Access Compliance Report

Public Rights-of-Way

Intersection ID: 6198	Main Street: FAIRES_FARM_RD	Cross Street: JEFFREY_BRYAN_DR	Location:	N
ADA ID: C870231FCF25	Ramp Type: PerpDiag	Initial Pass/Fail: Fail	Overall Compliance: No	Severity Score: 21.25
Codes/Mitigation Info/Possible Solution		Field Measurements/Component Compliance

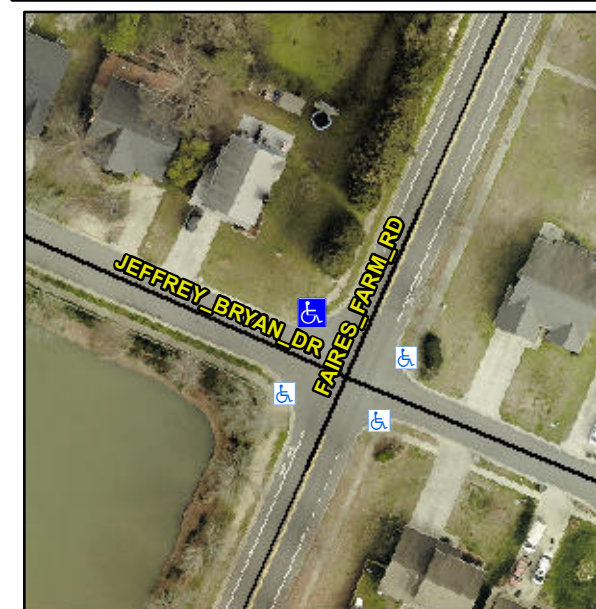
R304.5.1, R304.2.2

Compliance	Description	Data	Compliance	Description	Data
N/A	Ramp Length (in)	48.0	No	Ramp Slope (%)	8.5
No	Ramp Width (in)	46.0	Yes	Ramp XSlope (%)	0.8
N/A	Flare Type LT	N/A	N/A	Flare Type RT	N/A
N/A	Flare Slope LT (%)	N/A	N/A	Flare Slope RT (%)	N/A
N/A	Flare Traversable LT?	N/A	N/A	Flare Traversable RT?	N/A
N/A	Landing Length (in)	N/A	N/A	DWS Provided?	N/A
N/A	Landing Width (in)	N/A	N/A	DWS Contrast?	N/A
N/A	Landing Slope (%)	N/A	N/A	DWS Length (in)	N/A
N/A	Landing X Slope (%)	N/A	N/A	DWS Full Width?	N/A
N/A	Landing Curb? (Y/N)	N/A	N/A	DWS Offset (in)	N/A
N/A	Shared Landing?	N/A			
N/A	Gutter Ponding?	N/A	N/A	Gutter Slope (%)	N/A
N/A	Gutter Lip Ht (in)	N/A	N/A	Gutter X Slope (%)	N/A
N/A	Painted X Walk1?	No	N/A	Painted X Walk2?	No
	X Walk 1 Direction	To SW		X Walk 2 Direction	To SE
N/A	X Walk 1 Width (in)	N/A	N/A	X Walk 2 Width (in)	N/A
	X Walk 1 Slope (%)	3.7		X Walk 2 Slope (%)	1.0
	X Walk 1 X Slope (%)	0.9		X Walk 2 X Slope (%)	3.2

Remove & Replace Curb Ramp With Two New Directional Ramps or Equivalent.
